The City of San Diego

Staff Report

SUBJECT: Consideration of Alternate Methods and Materials Application PRJ-1165197 for 3450 El Cajon Boulevard – (PRJ-1077714)

CONSTRUCTION TOLERANCES
CODE MODIFICATION
EQUIVALENT FACILITATION
ALTERNATE MEANS AND METHODS
CORRIDOR WIDTH
FEATURES FOR PERSONS WITH DISABILITIES
2019 CALIFORNIA BUILDING CODE

4

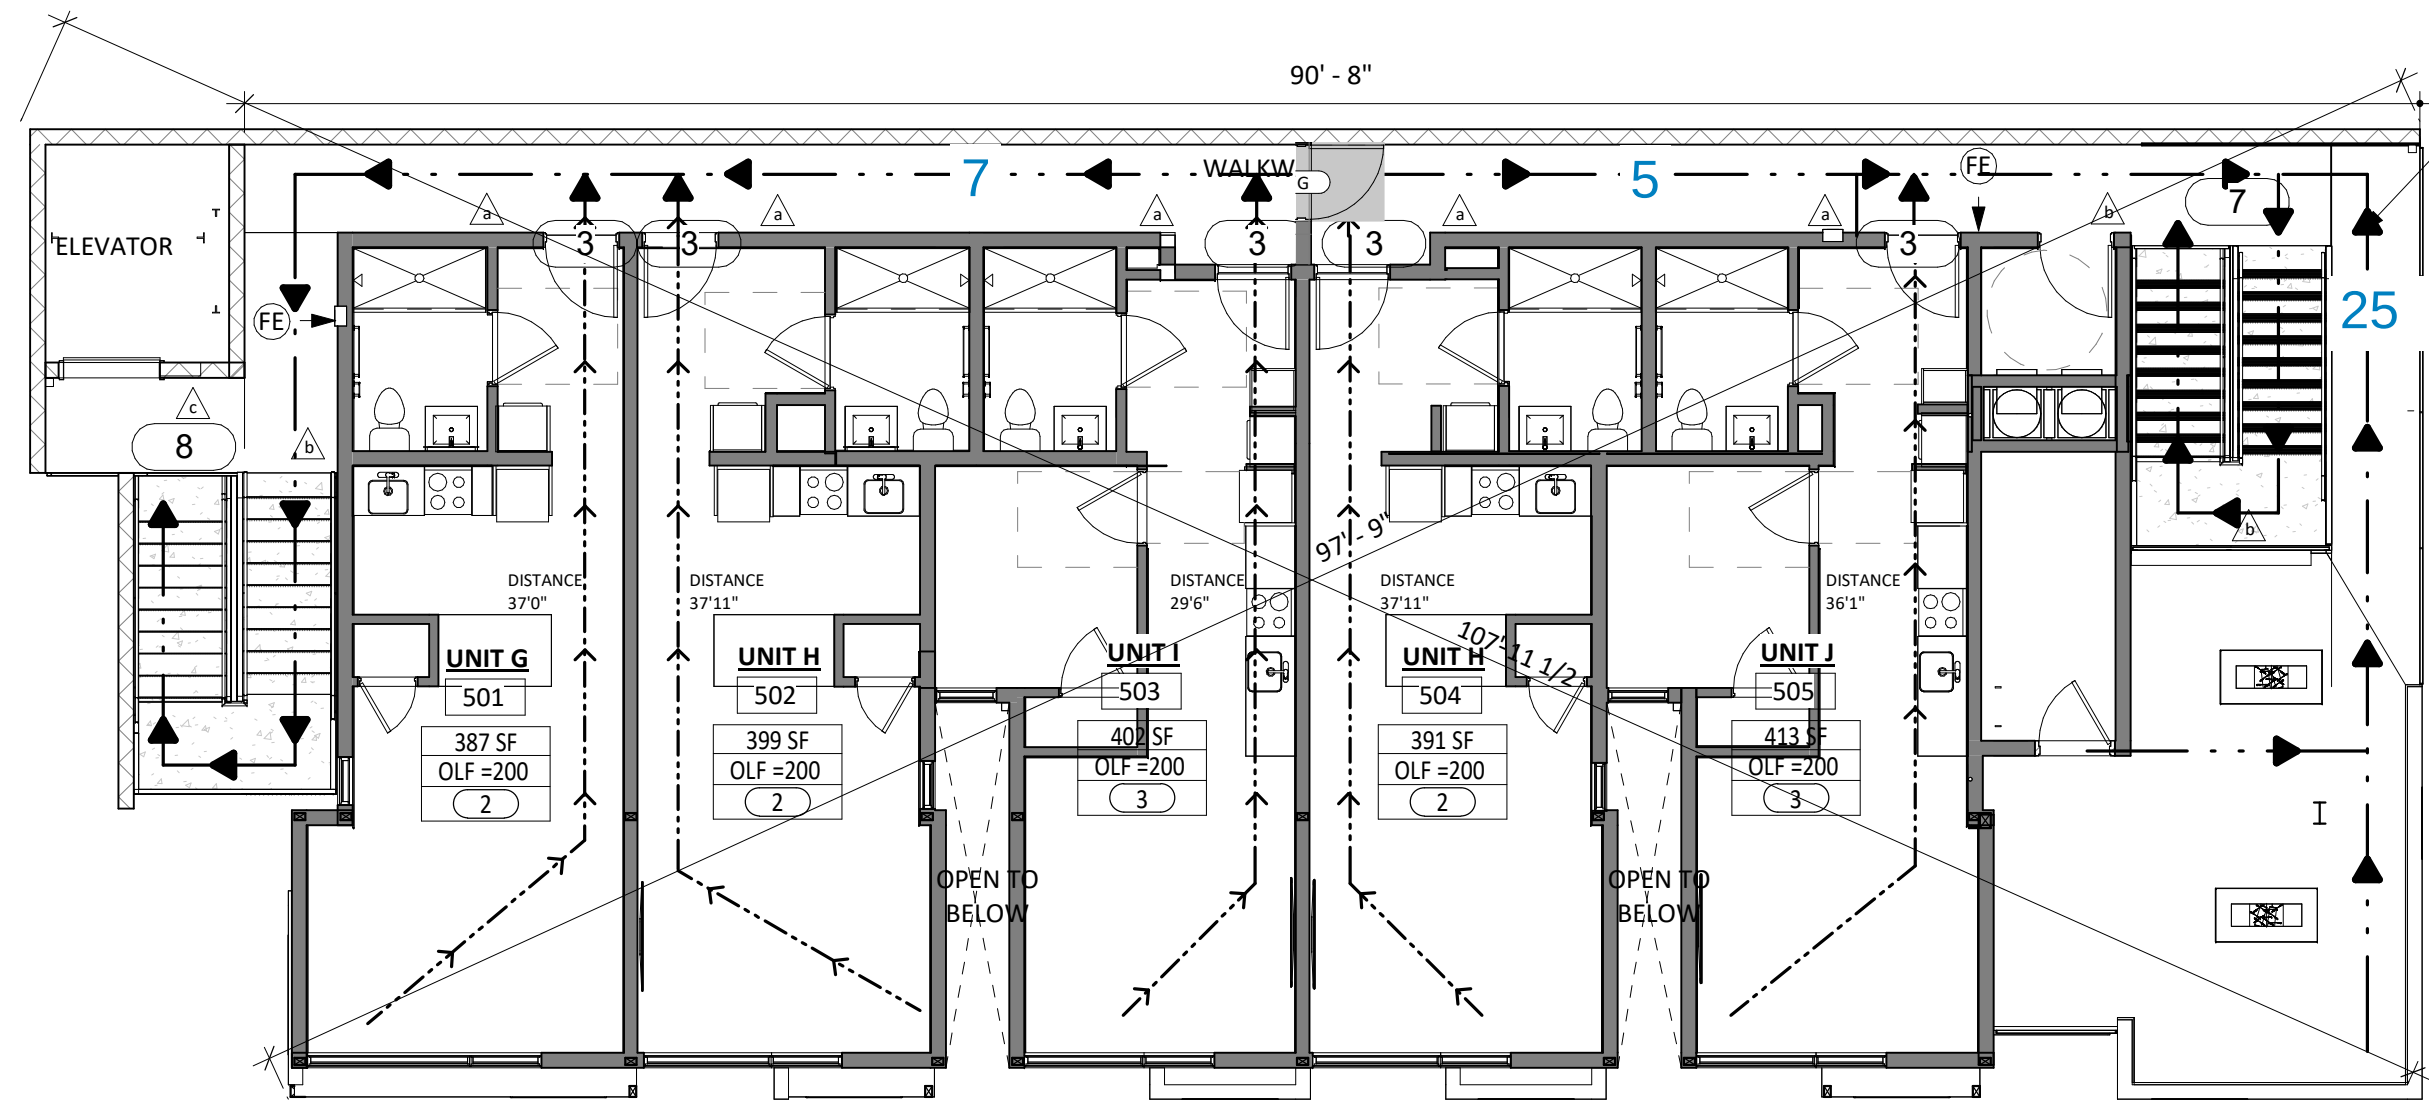
As shown on the approved plans for the means of egress,²⁰ the maximum occupant load is 7 persons in each of the separate corridors on either side of the horizontal exit towards the stairways. As such, these separate corridors must be at least 36 inches wide. As-built construction complies with this requirement.

²⁰ Architectural Drawings, Sheets T2.1, T2.2 – see modified attachment at end of this report.

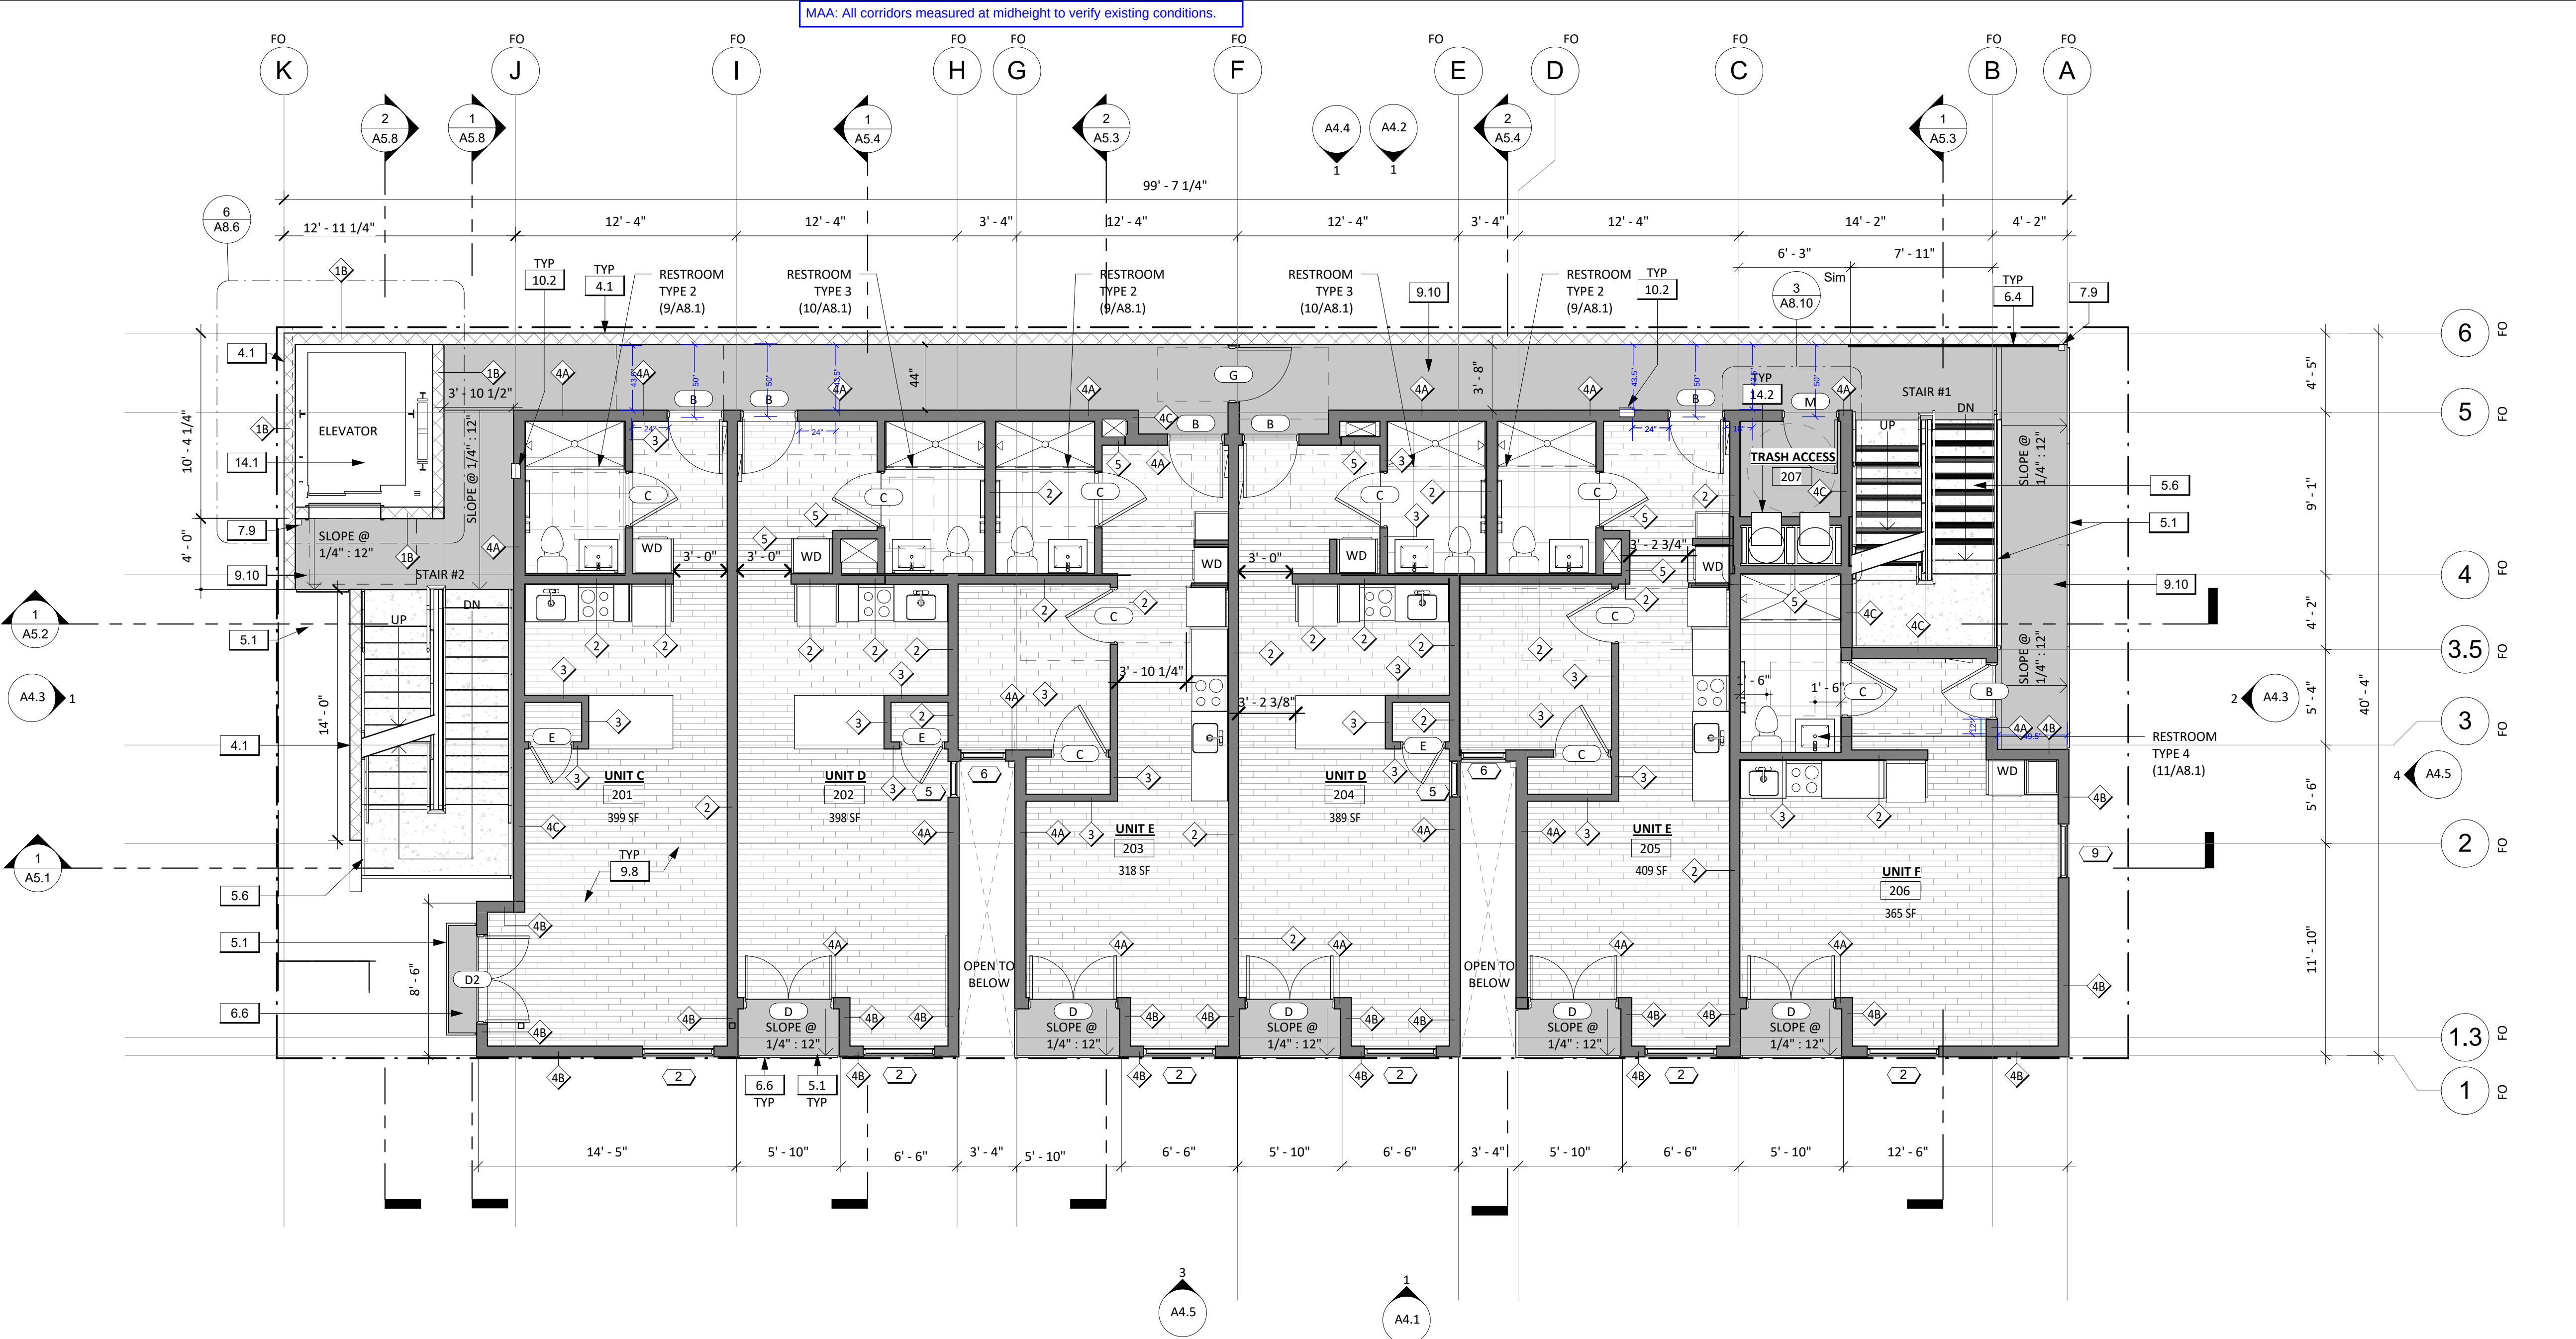
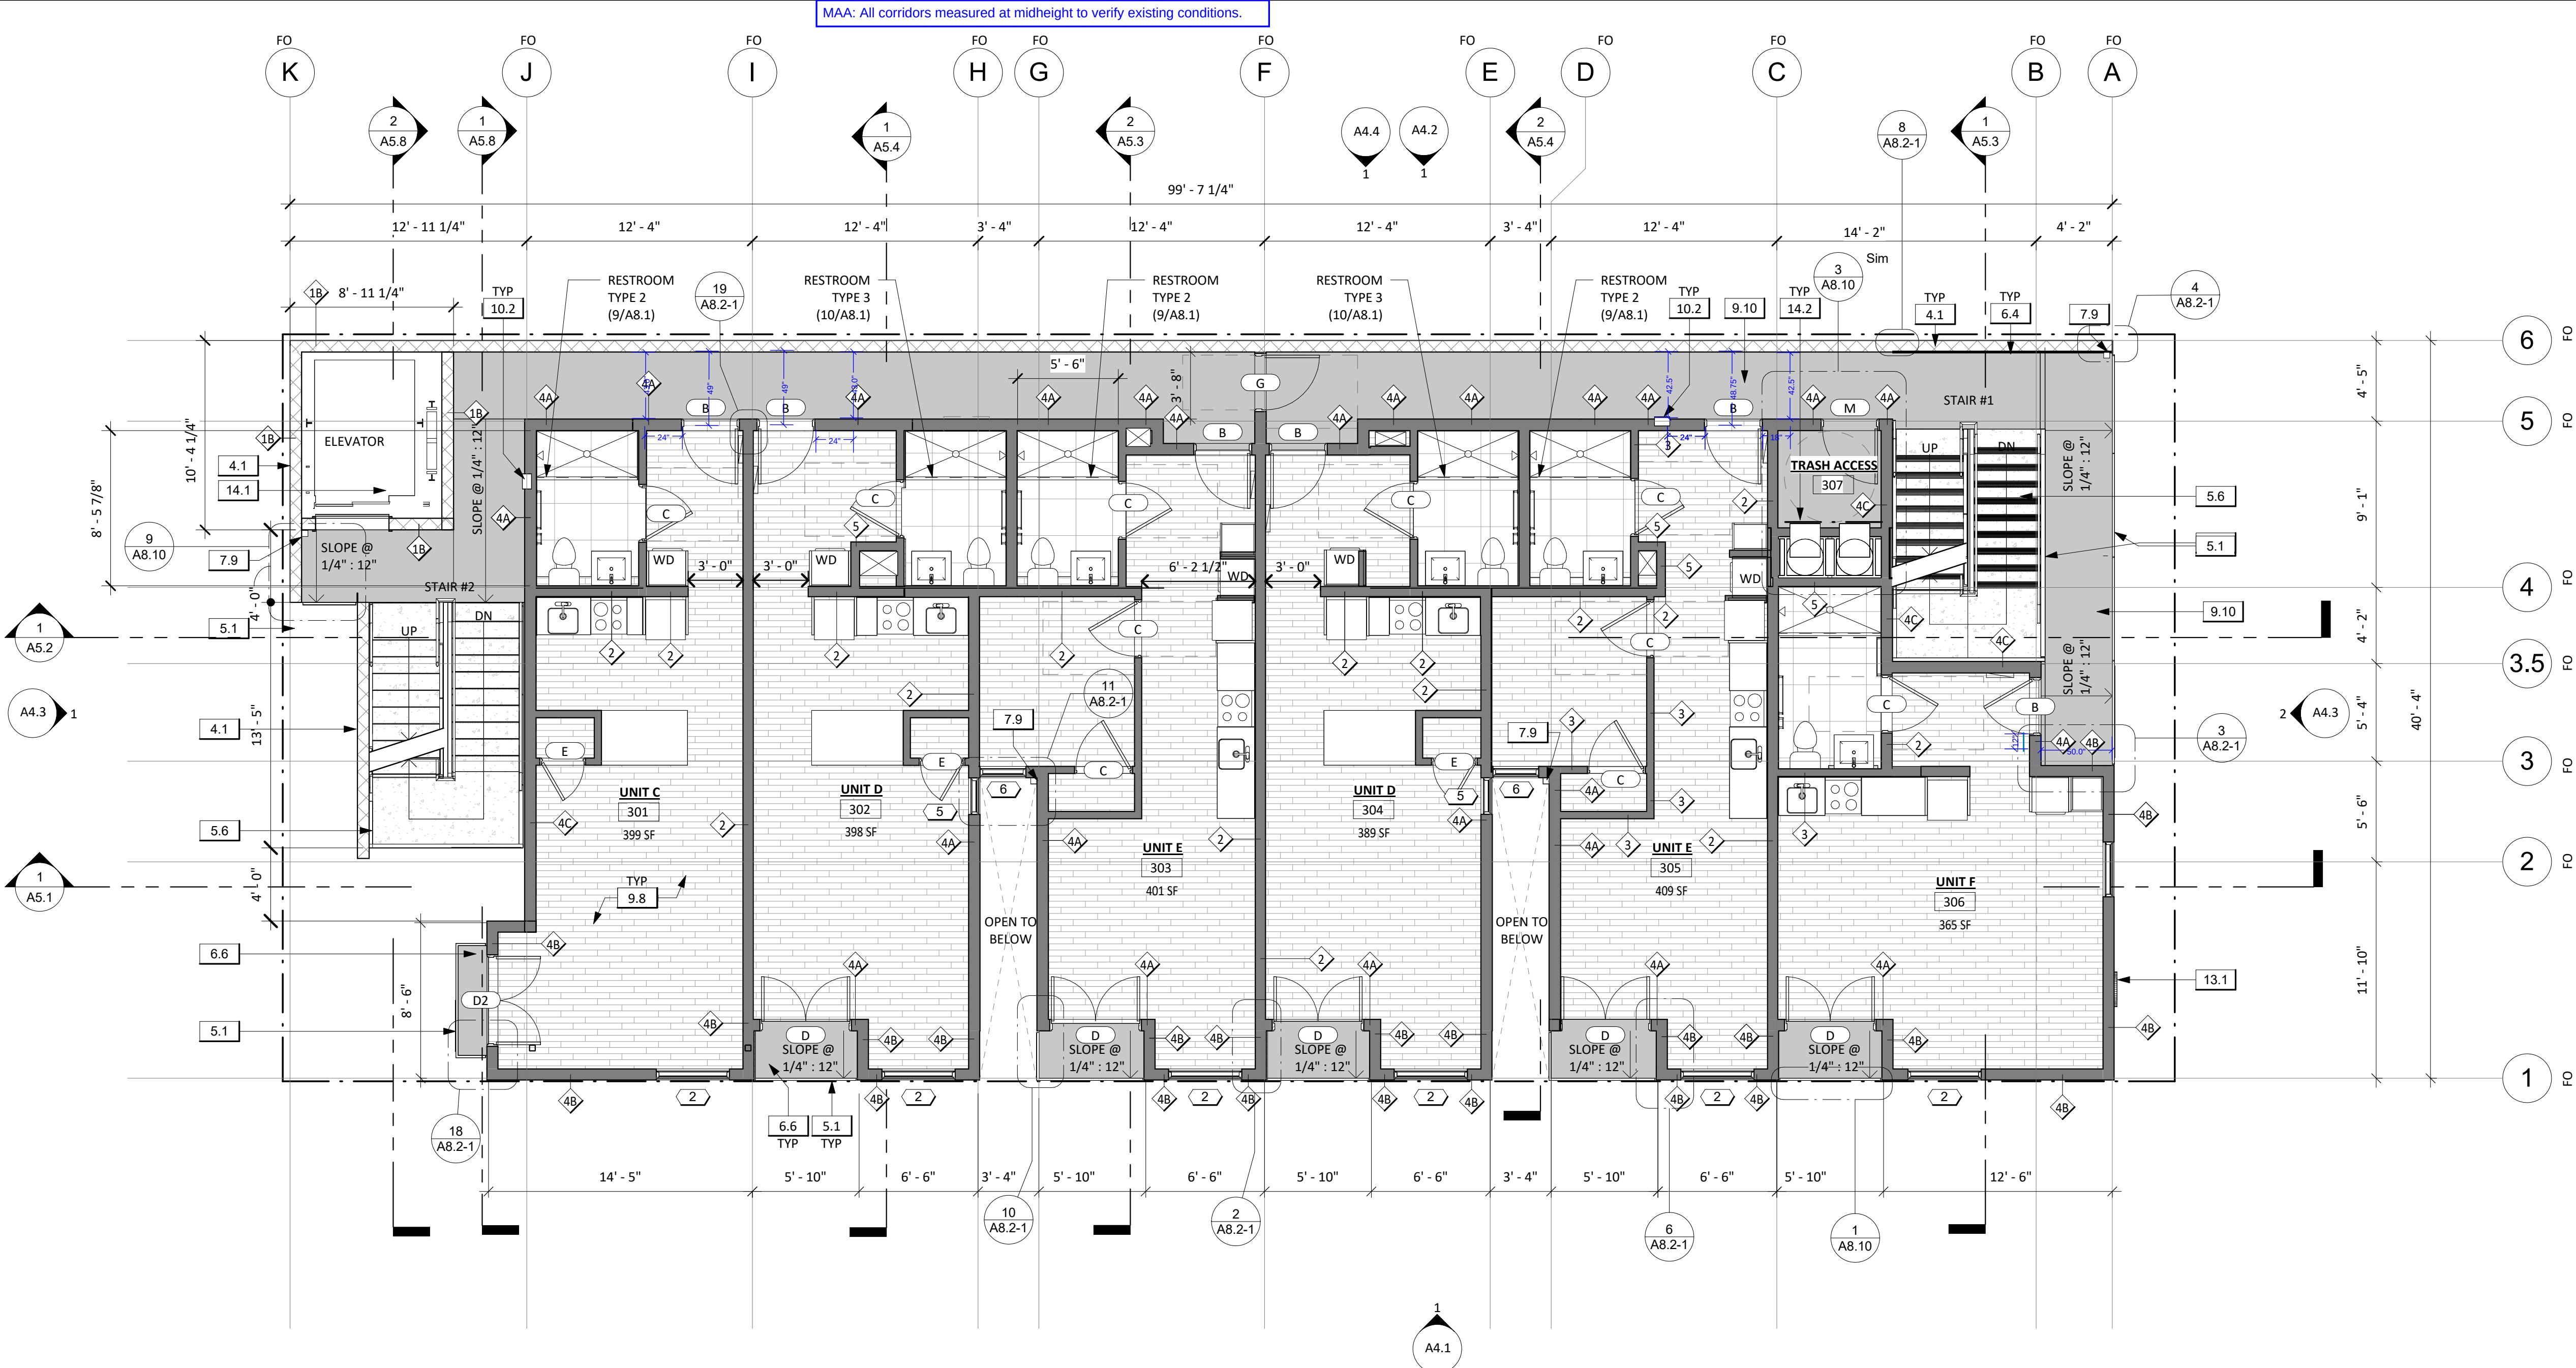
See table for Front Approach analysis on the following page. Measurements in the table for as-built corridor widths at the locations for door maneuvering clearances are taken from and shown on the attached floor plans at the end of this report.

See table for Side Approach analysis on the following page. Measurements in the table for as-built corridor widths at the locations for door maneuvering clearances are taken from and shown on the attached floor plans at the end of this report.

1. Remove door closers and replace the standard door hinges with fire-rated self-closing hinges at the affected 16 doors i.e. 4 trash rooms doors (Rooms 207, 307, 407 and 508) and 12 unit entrance doors (Unit Nos. 201, 202, 205, 301, 302, 305, 401, 402, 405, 501, 502, and 505).
